ENGINE - FUEL AND CONTROL - FUEL SYSTEM AIR TUBES, P12.5 TUBE SUPPORT BRACKET, WIRE LOCKING PROVISION - CATEGORY CODE 6 - MOD.ENG-73-0003

V2500-ENG-73-0003

Modification of diagnostic tube support bracket
Fig.1

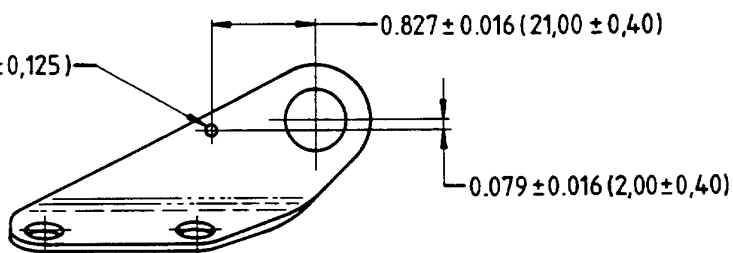
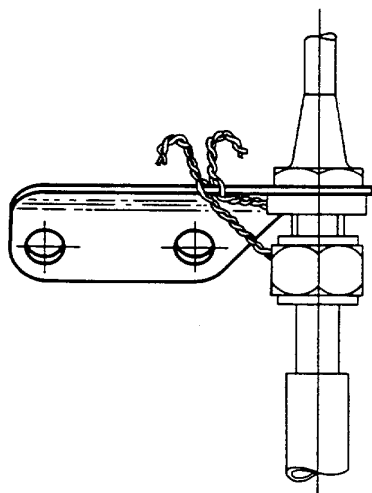
- (1) The changes introduced by this Bulletin are as follows:
 - (a) The P12.5 diagnostic tube support bracket at the flexible hose to rigid tube joint has an additional hole for wire locking purposes.
 - (b) Both the P12.5 flexible hose union and rigid tube retention nut are wire locked through the additional hole in the diagnostic tube support bracket.
- (2) Existing diagnostic tube support brackets can be reworked, see Figure 1.
- (3) Revised wire locking for the P12.5 flexible hose union and rigid tube return nut, see Figure 2.

Procedure	Supplementary Information	
(a) Mark position of the hole and centre punch the hole centre	Refer to Figure 1.	
(b) Drill the hole in the bracket	Refer to Figure 1. Clamp the bracket in the vice on a pillar drill and use 0.063in. dia (1,6 mm) drill.	
(c) Remove the burrs from around the hole		
(d) Crack test the bracket	Refer to SPM, TASK 70-23-01-230-501	
(e) Re-identify with new part number - vibro-engrave adjacent to existing part number	New Part No.	Old Part No.
	UP11228	UP11034

$\phi 0.0679 \pm 0.0049$ ($\phi 1,725 \pm 0,125$)

REWORK OF BRACKET, ANGLE

Modification of diagnostic tube support bracket
Fig.2

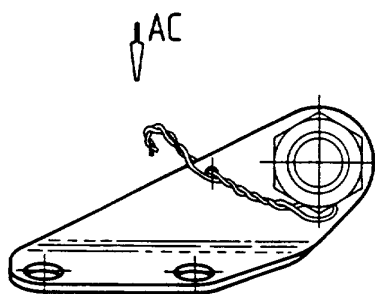
- (1) New UP11228 angle bracket is interchangeable with in use bracket.
- (2) Assemble new UP11228 angle bracket in accordance with approved overhaul procedures, Engine Manual, 72-00-32, Installation.
- (3) Assemble the tube support bracket onto the rigid tube and tighten the rigid tube retention nut and flexible hose union and wire lock in accordance with current overhaul procedures (Refer to Engine Manual, 72-00-32, Installation).

REPEAT VIEW AT AB
SHOWING CONNECTIONS LOCKED
FOR SAFETY WITH WIRE
AFTER MODIFICATION
